Town of Truro

Staff Report

Cloverleaf Truro Rental Housing Comprehensive Permit

Re: Peer Review
Cloverleaf Parcel
Highland Road
Truro, Massachusetts

SCHEMATIC FLOW PROFILE:

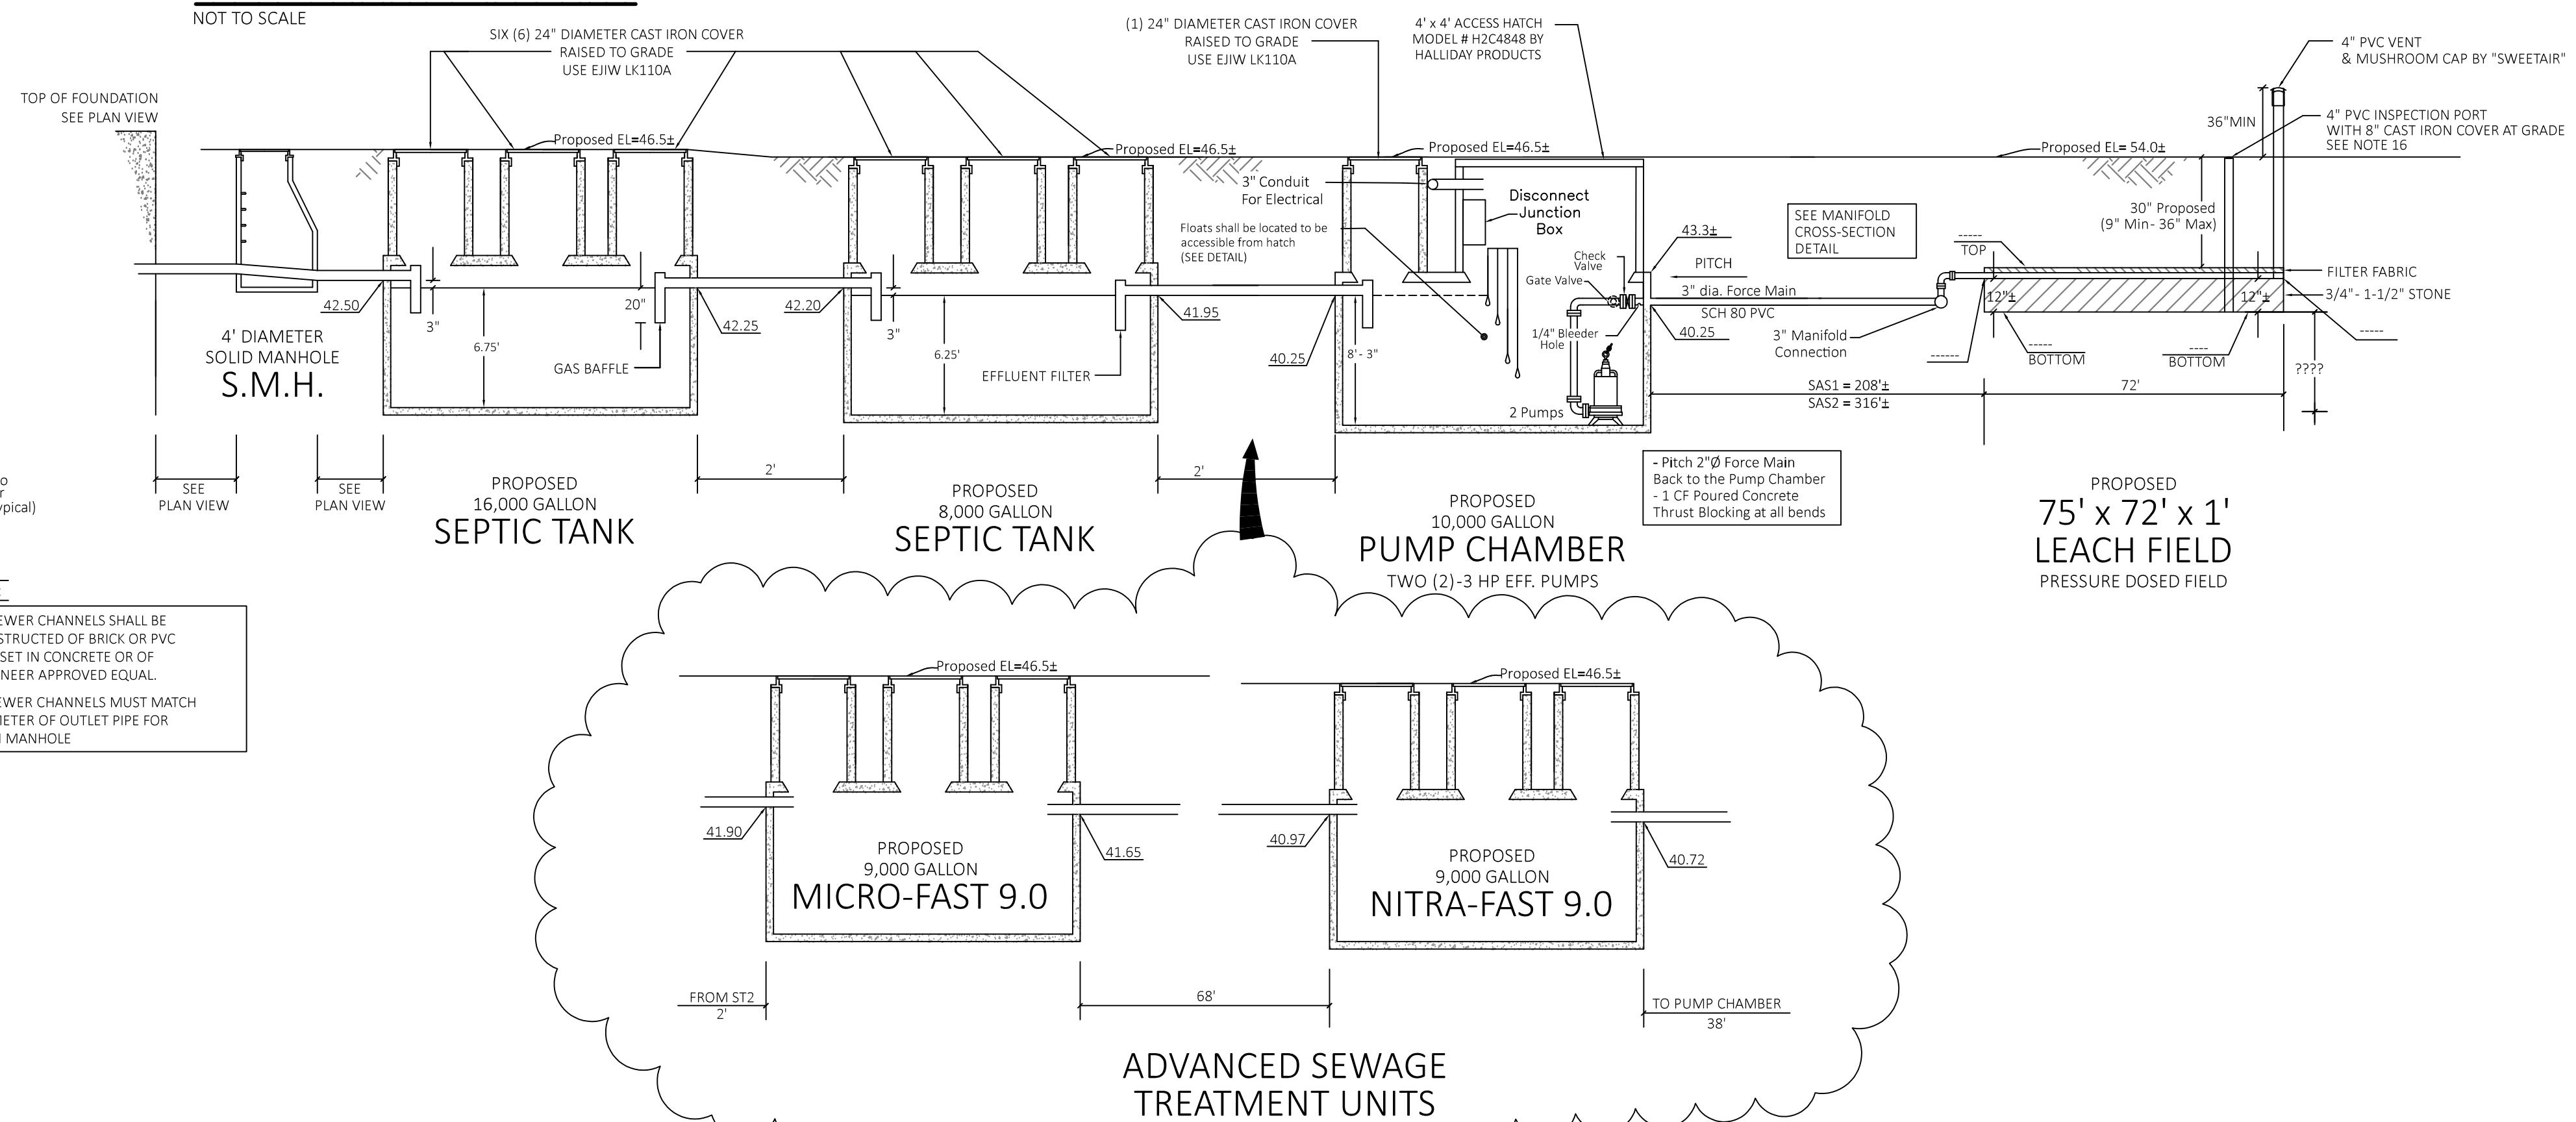
2. Test pits do not appear to have been performed in the areas if the proposed leaching facilities. The plans note that one boring was dug using a hand auger, but the location is not indicated on the plans. Title 5 requires a minimum of two deep hole test pits in the primary leaching areas and two in the reserve areas along with percolation tests.

3. Elevations should be provided on the top of tanks and leach field to ensure the minimum/maximum cover over the entire system meets Title 5 and/or H-20 loading as required.

4. Pipe sizes/slopes are not labeled. HW recommend 6" minimum and cleanouts at bends where no manholes are proposed. Additionally, it appears that portions of the septic system piping will be located underneath "landings" with steps on some of the buildings including units 17-18, 13-15, 10-12, 14-16, and 18-20. HW recommends locating sewer lines away structures or footings.

6. The leach field detail should clearly label the 5-foot minimum estimated seasonal high groundwater (ESHGW) separation, along with an explanation of how the ESHGW was determined. The applicant will also need to document that groundwater mounding will not impact the minimum separation between the bottom of the leaching field and groundwater. Given the dept to water, this should not be a problem in the primary leaching areas but might be an issue in the reserve areas.
7. HW recommends allowing for more than one day of storage in the pump chamber as a safety factor to account for potential power outages. Alternatively, backup power could be provided.
8. HW recommends that the Applicant provide information on the operation and maintenance (O&M) for the septic system components.

Figure 1

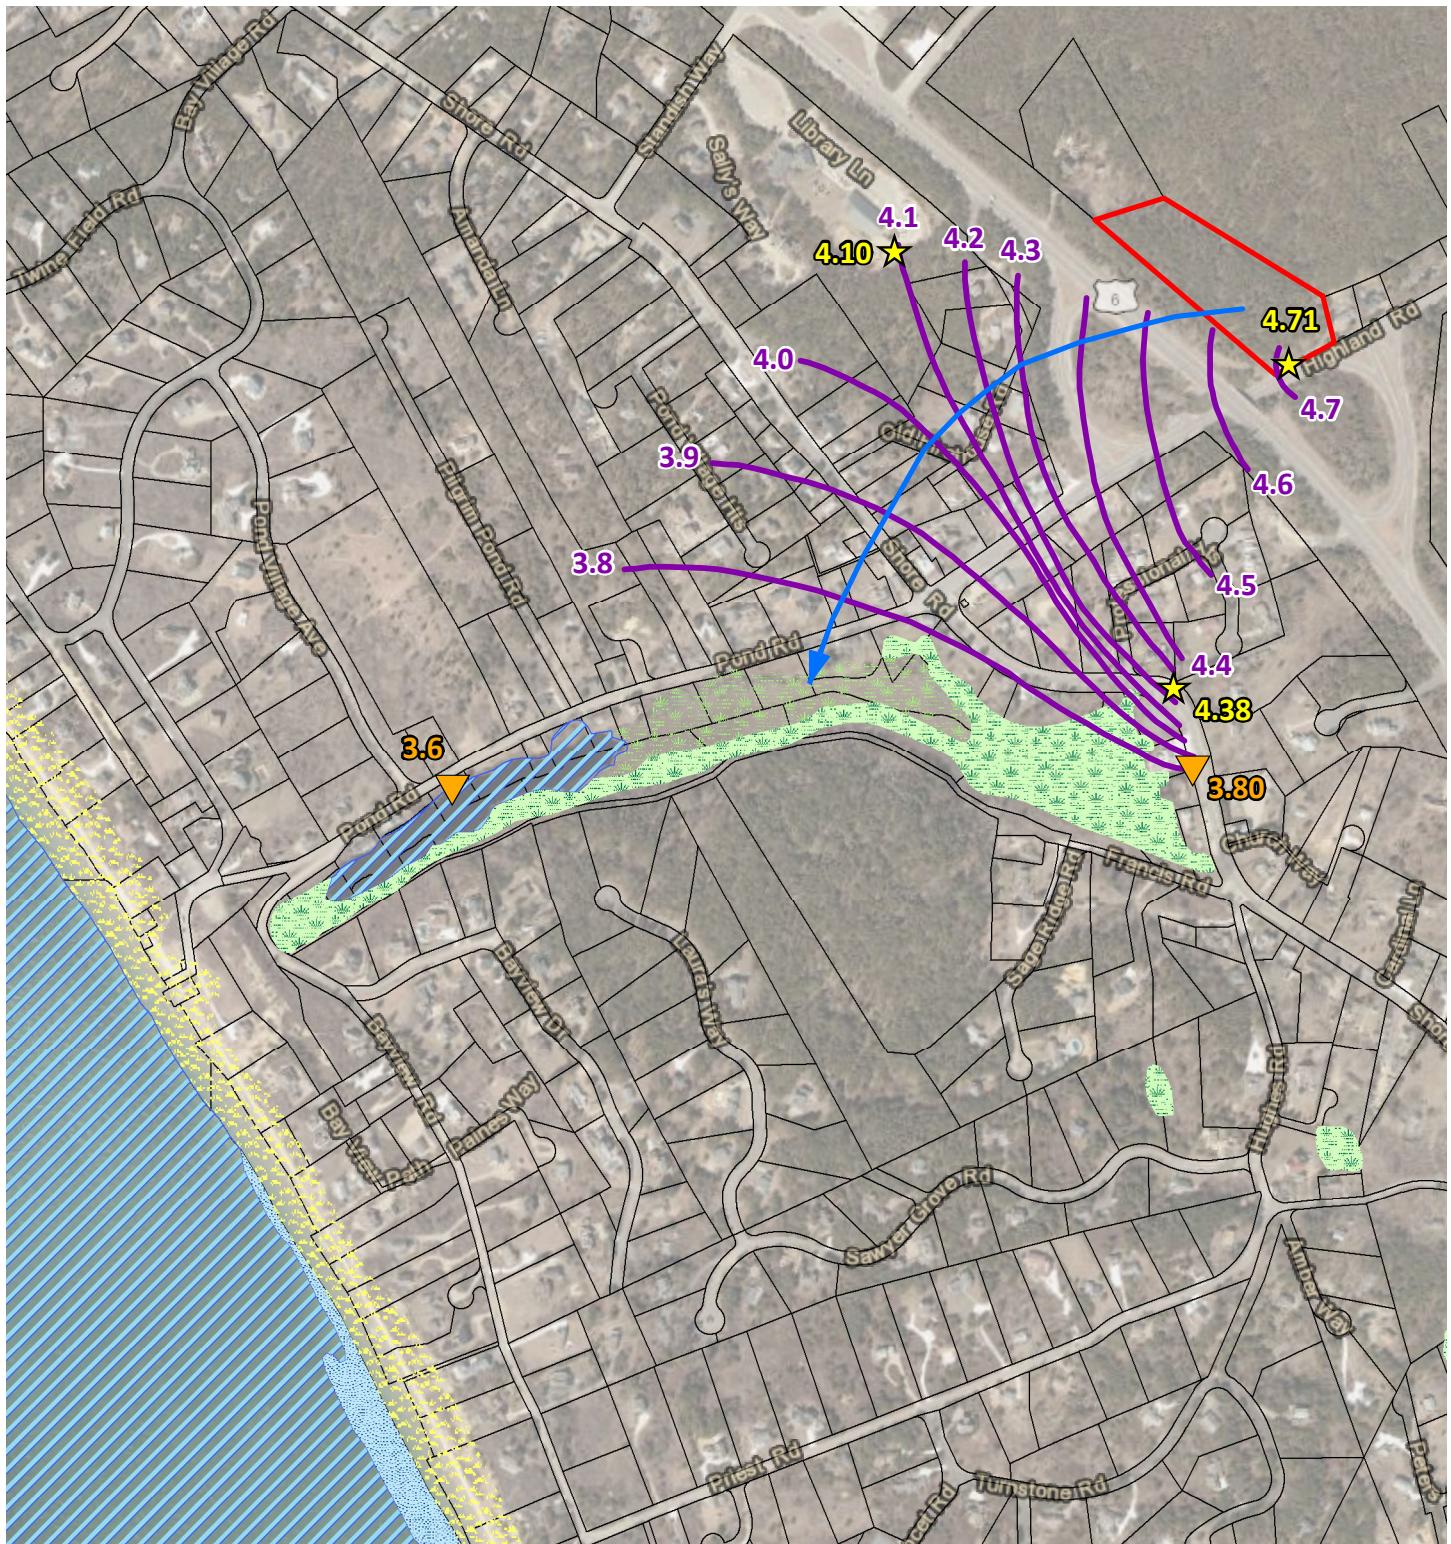
HW's review included the installation of three monitoring wells to map the direction of groundwater flow in the vicinity of the proposed project. We evaluated the impact to downgradient water resources from the septic system and stormwater management practices proposed for the site. We also reviewed the engineering design plans and provided comments and questions on the septic system design, the stormwater management design and the overall layout of the property, including erosion and sedimentation control practices. The comments below start with our evaluation of the water quality issues identified with the project and are followed with specific comments and questions on the design plans.

On January 27 and 28, 2020, HW installed 3 groundwater monitoring wells (B1, B2 and B3) off-site and downgradient of the proposed housing development. On February 4, 2020, depth to water measurements were collected at the three groundwater monitoring wells as well as the culvert outfall off of Shore Road and Village Pond. These sample locations and groundwater contours can be found as Figure 1. Groundwater in the vicinity of the site flows to generally to the south, across Route 6 and eventually flows into Pilgrim Pond or the surrounding wetland resources.
